Document number T10/99-317r0

Comments against SPI-3 rev 10

Add the following figure x describing the test fixture to section E.3.1.2 with the title "Test fixture for single ended capacitance measurement".

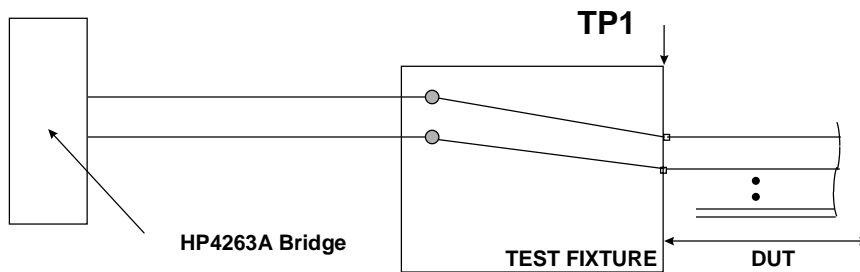
In section E.3.1.2

change: See E.2.2.2 for appropriate test fixtures.

To: Figure x shows the configuration to use for this measurement procedure.

[Add a new Figure x shown below titled "Test fixture for differential capacitance measurements"].

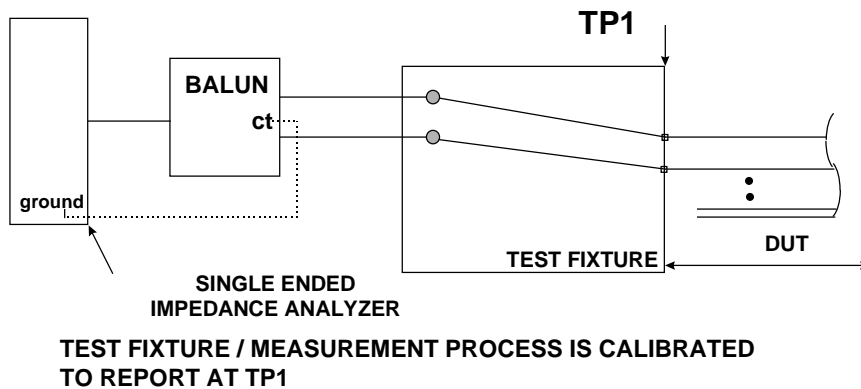
In section E.3.2.2

See E.2.2.2 for appropriate test fixtures.

Refer to Figure x for the proper test configuration.

Add new figure x given below showing the test fixture with the title "Propagation time measurement setup".

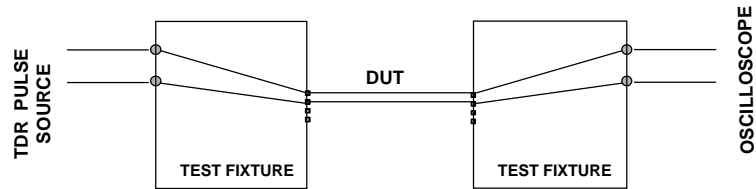
In section E.5.2 change:

See E.2.2.2 for appropriate test fixtures.

To: See Figure x for appropriate test fixture.
